SOUTH CORE - MEZZANINE FLOOR - LIFT LOBBY - PART 2 STONE LAYOUT - 1:20

HG Drawing No.: C5527-HG-S221

Project: **Centre Point London**
Drawing Title: **Stone Layout part 2 - Lift Lobby Mezzanine Floor - South Core**

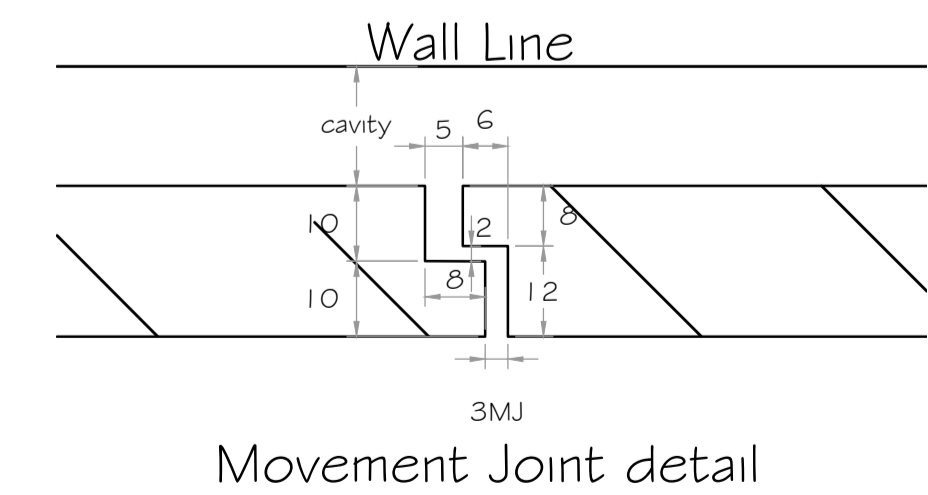
Paye Note:
- coordinate panel & fixing with services.
- Sprinkler routes to be coordinated with Architect Note 13/04/2017:
-Info from LS required to coordinate M+E including the side wall sprinkler routes.
